To: [Department of Planning, Industry and Environment](#)
Produced: Michele Zornitta (Associate Water Resources Engineer -WSP)
Reviewed: John Pickering (Associate Engineer - WSP)
Subject: **Waterloo Metro Quarter OSD**
SD-10439 Central Precinct – Response to submission comments
Date: 4 March 2021

This note has been prepared to respond to the comments dated 25 November 2020 raised by the Environment, Energy and Science Group (EES) to the Department of Planning, Industry and Environment (DPIE) during the public exhibition period for Waterloo Metro Quarter Over Station Development (OSD).

Specifically, this note responds to the comments for the Central Precinct SSD DA (SSD-10439). Figure 1 below represents a schematisation of Waterloo Metro Quarter OSD – the area in green identifies the proposed Central Precinct.

Figure 1: Waterloo Metro Quarter site, with sub-precincts identified

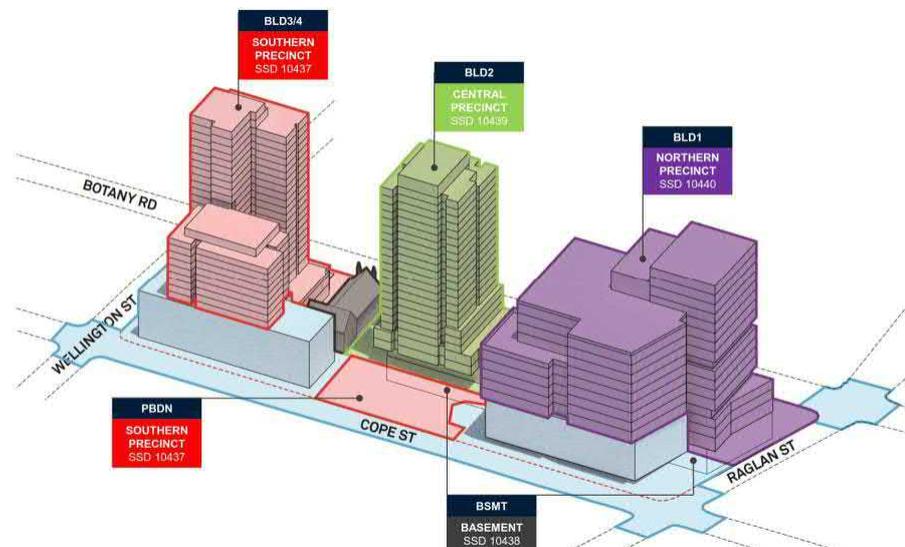
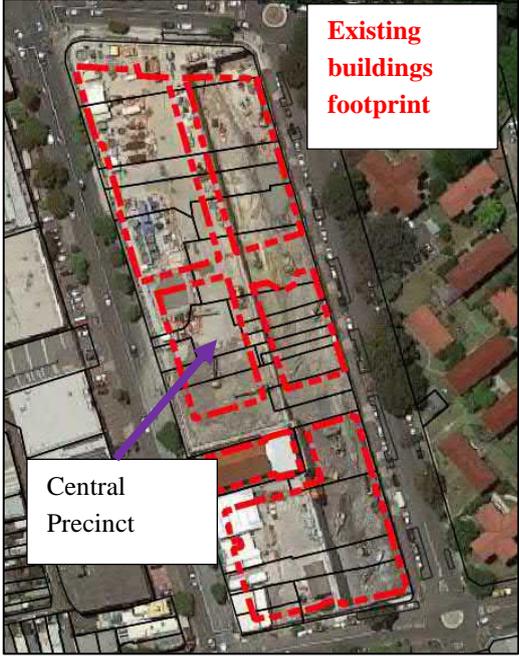
| Comment | Response |
|--|--|
| 2 | <p>The individual buildings of the over station development are not expected to cause any flood impacts; however, the ancillary road works are predicted to cause unacceptable impacts.</p> |

| Comment | Response |
|--|--|
| | <p>As noted by the EES reviewer, the individual buildings of the OSD are not expected to cause any negative flood impacts. This is due to the footprint occupied by the proposed buildings and Cope Street plaza being less than the existing buildings as shown in the figure below.</p> |

| | |  <p>The Central Precinct development does not affect topography levels outside the existing buildings footprint (i.e. pre-development conditions prior to any work associated with the metro station construction). As such, it is not possible for the Central Precinct to negatively affect flood conditions to the adjacent land.</p> <p>Flood impacts described in the Stormwater Management Strategy and Flood Impact Assessment – SSD-10439 Central Precinct report are caused by the proposed road works along Cope Street that forms part of the metro station Critical State Significant Infrastructure (CSSI) application scope. The road works along Cope Street are not part of this development application (SSD-10439).</p> |

Waterloo - OSD
 Proposed Scenario - 1% AEP
 Water Level

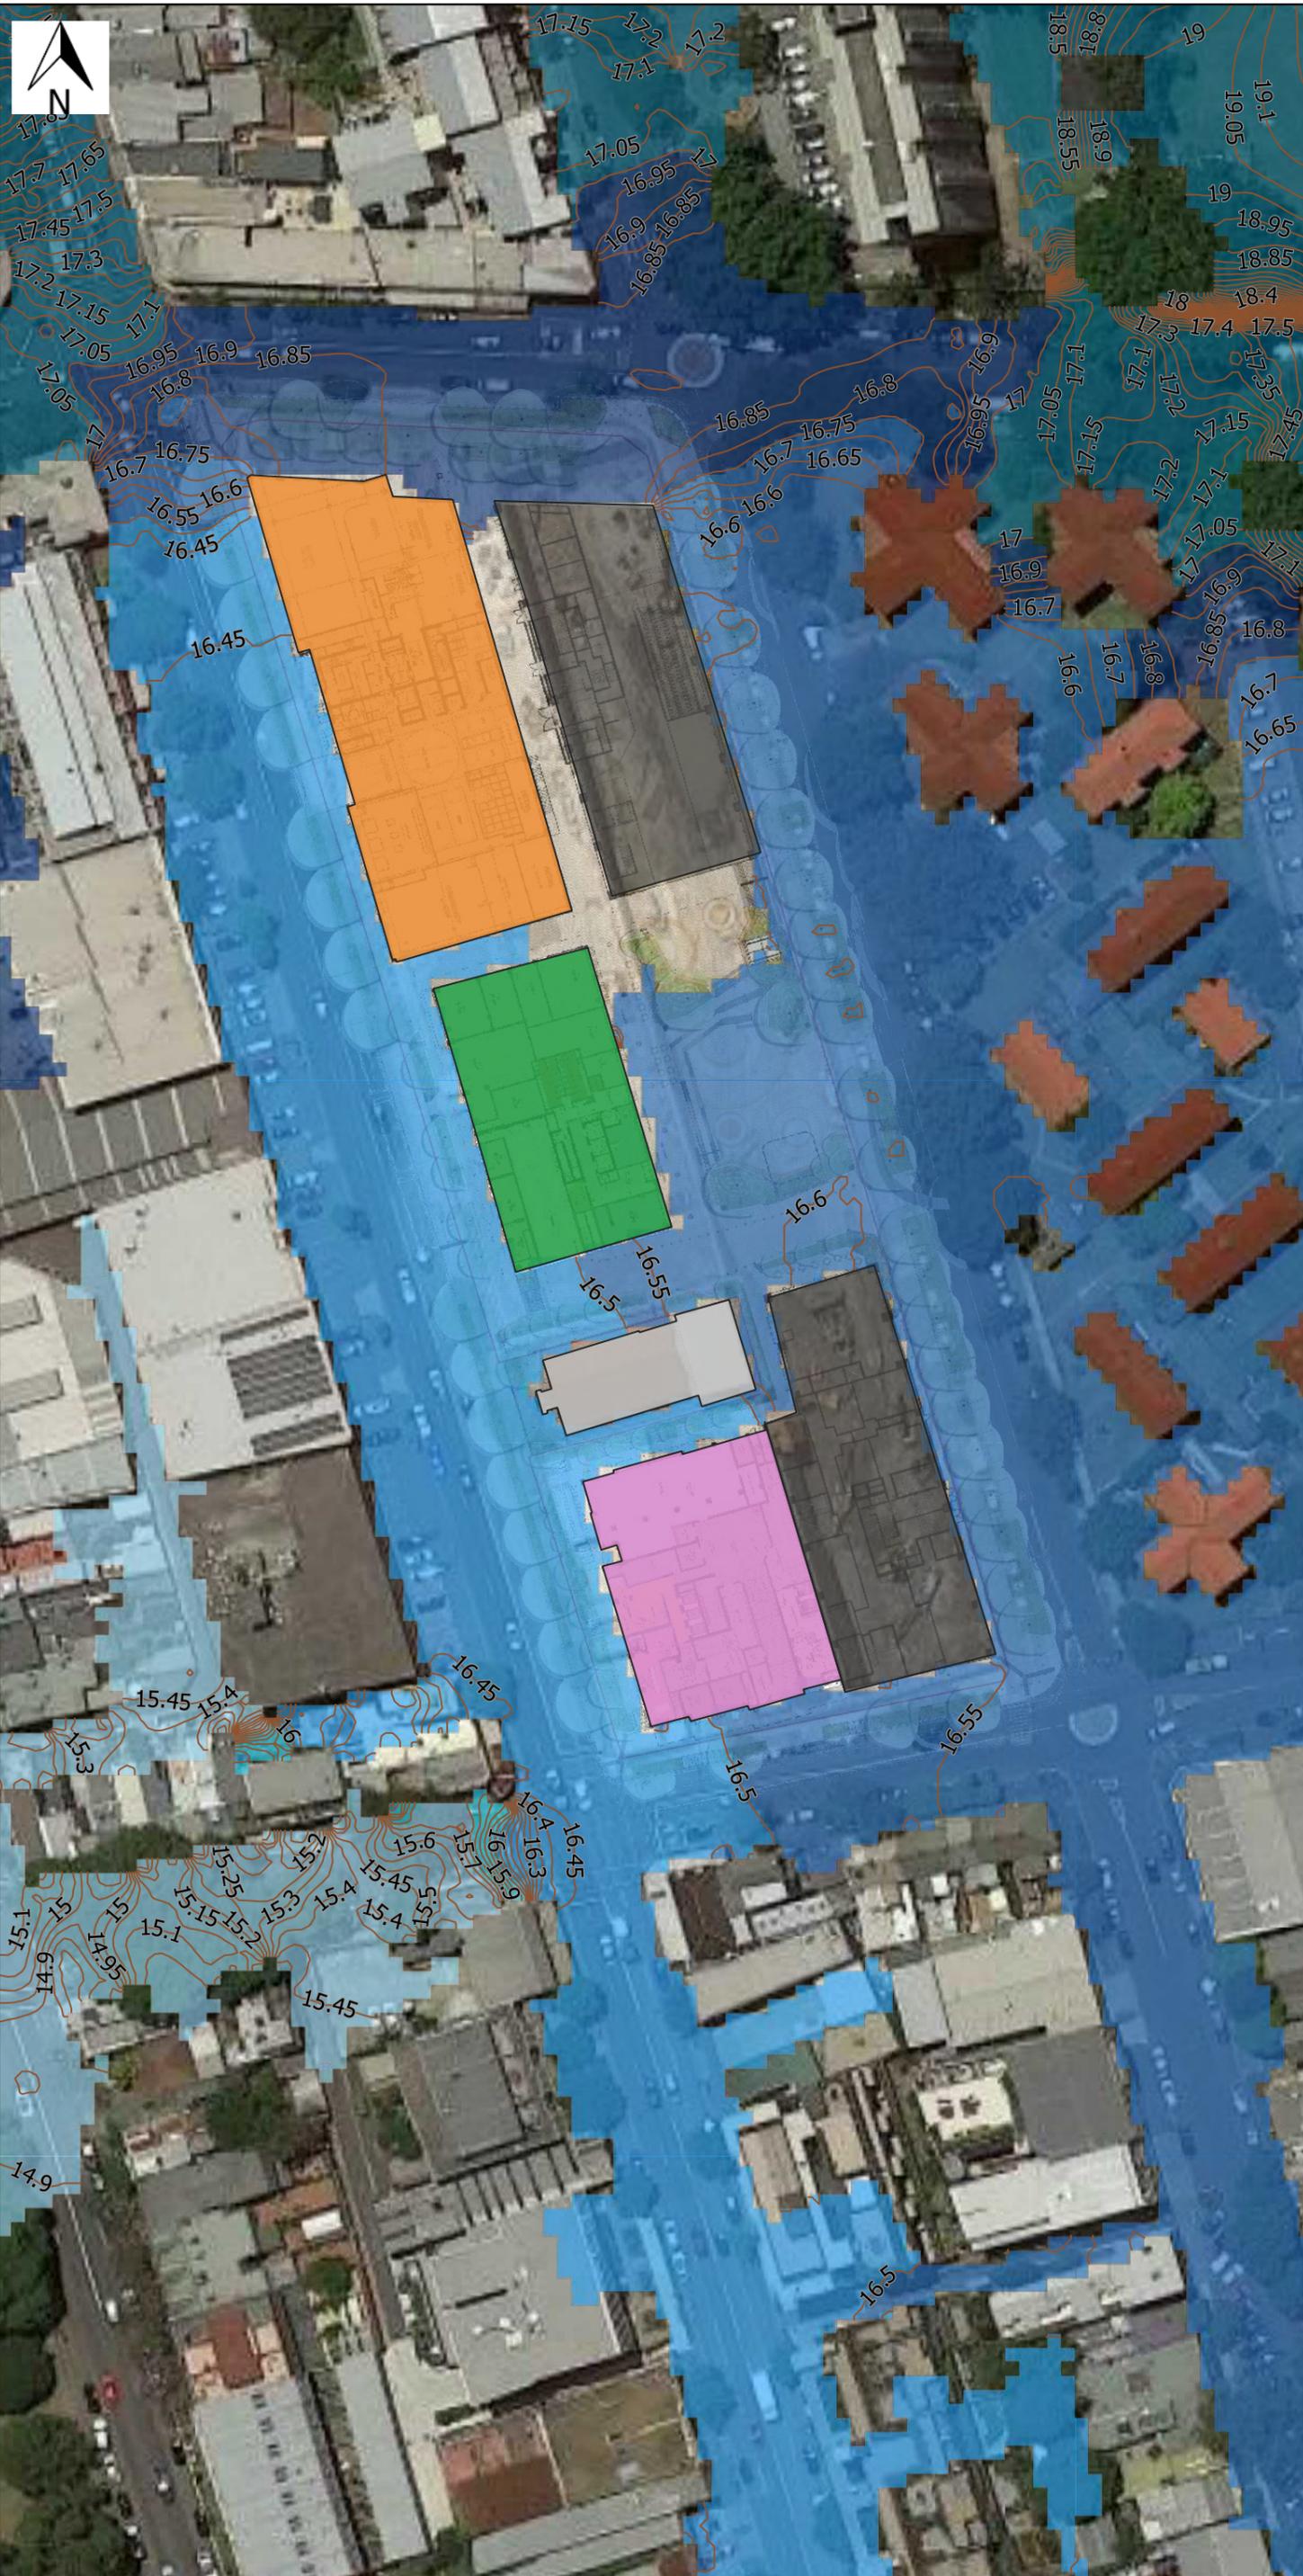
| Comment | Response |
|--|--|
| 1 | <p>The reports have not included flood level mapping for any scenarios, except the 1% AEP flood event plus climate change. This is a significant omission. This mapping, including water level contours at appropriate intervals, must be provided as a minimum for the 5% and 1% AEP flood events and the PMF event. It is not possible to verify any of the flood level information quoted in the report without this mapping. A proper review of the submission cannot be completed until this has been provided. The frequency of typographical and grammatical errors does not give the reader any confidence that the appropriate degree of checking and verification has been completed in general.</p> |

| Comment | Response |
|--|--|
| | <p>Maximum flood levels for the 1% AEP, 1% AEP + Climate Change (CC) and PMF flood events are included in Table 4: Design flood planning levels – Building Floor Levels of the Stormwater Management Strategy and Flood Impact Assessment – SSD-10439 Central Precinct report. Flood levels included in Table 4 represent the maximum water levels for the 1% AEP, 1% AEP+CC and PMF flood events in correspondence to relevant building areas.</p> <p>Flood levels for the 5% AEP flood event were not originally included in the flood impact assessment report as they were not relevant in the determination of flood planning levels. Flood planning levels have been informed by the 1% AEP, 1% AEP+CC and PMF maximum flood levels.</p> <p>Water level contour maps (with a 50 mm contour interval) for the 5% AEP, 1% AEP and PMF flood events have been prepared and attached to this response as requested by the EES reviewer.</p> <p>The report and technical work developed for Waterloo Metro Quarter OSD has been reviewed and approved by the appropriate WSP flood engineers.</p> |
